AMENDMENTS TO THE DRAWINGS

REMARKS

Submitted with Response to Office Action
dated December 28, 2005

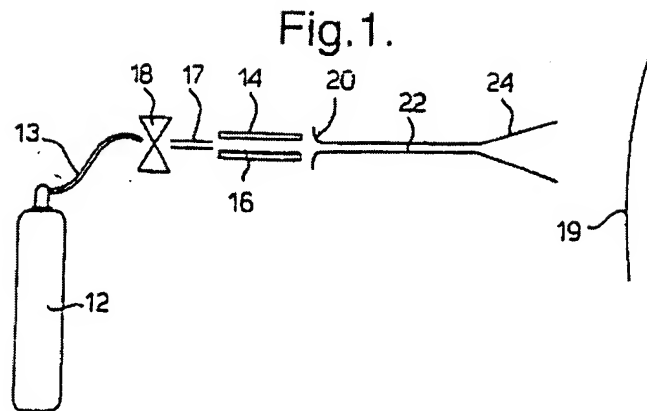
The Office Action stated that Heinzen discloses a needleless injection device that includes a rupturing membrane closure means 18, diameter driver chamber 13, constant diameter duct section 22,

dose of particles in region of closure means 14, divergently contoured nozzle 24 through which a flow travels, whereby the device generates an accelerated gas stream upon rupturing the membrane.

The Office Action acknowledges that establishing a quasi-steady flow upstream of a shock wave as well as entraining and accelerating particles in the quasi-steady flow is not taught by Heinzen. The Office Action, however, asserts that these elements are inherent to the device set forth in Heinzen. In support of this assertion, the Office Action states that Heinzen discloses the same structure as recited in the Applicants' claims and that due to this identity the Heinzen device will inherently function as the device claimed by the Applicants and therefore produce the associated waves and effects in use with shock waves.

The Applicants respectfully disagree. The device disclosed in Heinzen is represented in Figure 1 (set forth herein below).

The Heinzen device, on the other hand, is not configured in this manner. As can be seen with

reference to Figure 1, above, the carrier particles (16) are forward (i.e., downstream) of the tubing element (13; which the Office equates with the Applicants' claimed driver chamber) and membrane (18). Hence, when the membrane (18) is ruptured the particles (16) will be downstream of (e.g., in front of) the primary shock wave. Because the particles will be in front of the primary shock wave the flow produced will be different from that produced by the device claimed by the Applicants. Therefore, Heinzen does not teach or suggest a device that is constructed such that the opening of the closure means (e.g., 53) produces a primary shock wave which travels along the duct section (52) in a downstream direction so as to establish a substantially quasi-steady gas flow in the duct section upstream of the primary shock wave.

FIG. 5

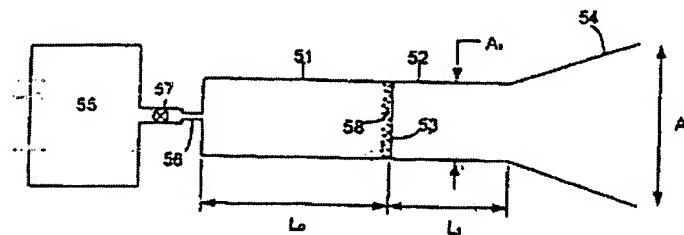
The Office equates the tubing (13) that connects the compressed gas (12) to the membrane (18) of Figure 1 with the driver chamber (51) of Figure 5. The Office additionally equates the membrane (18) of Figure 1 with the closure means (53) of Figure 5, the acceleration chamber (22) of Figure 1 with the duct section (52) of Figure 5, the carrier particles (16) of Figure 1 with the dose of particles (58) of Figure 5 and the nozzle (24) of Figure 1 with the divergently contoured nozzle (54) of Figure 5.

As set forth above, the device of claim 20 is constructed such that the opening of the closure means (e.g., 53) produces a primary shock wave which travels along the duct section (52) in a downstream direction so as to establish a substantially quasi-steady gas flow in the duct section upstream of the primary shock wave. Hence, the primary shock wave travels in front, or downstream, of the shockwave. This allows the particles to be substantially wholly entrained in a substantially quasi-steady flow.
